**Headlamp Bracket Deformity**

Vehicle Type: **911 Carrera (993), 911 Turbo (993) without Litronic headlight option**

Model Year: **911 Carrera, as of 1995 (S)  
911 Turbo, as of 1996 (T)**

Former Arrangement

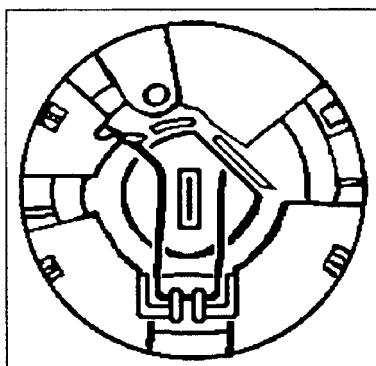
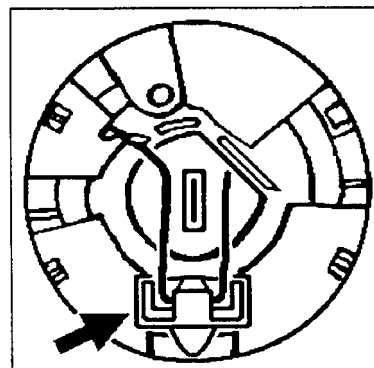
Concern: **Bracket for H1 headlamp (low beam) becoming deformed from heat.**

Information: The H1 lamp for low beam operation can become loose if the mounting area becomes deformed from heat. A new H1 lamp spring clip and retaining bracket are available, should this occur.

A repair kit, consisting of a stainless-steel spring clip and a modified retaining bracket should be installed, either as a preventative measure or a repair for deformity or warpage.

Work Procedure: Remove former H1 spring clip. Install new spring clip. Push the retaining bracket over the base area of the spring clip mounting. The retaining bracket must fully engage onto the lamp housing.
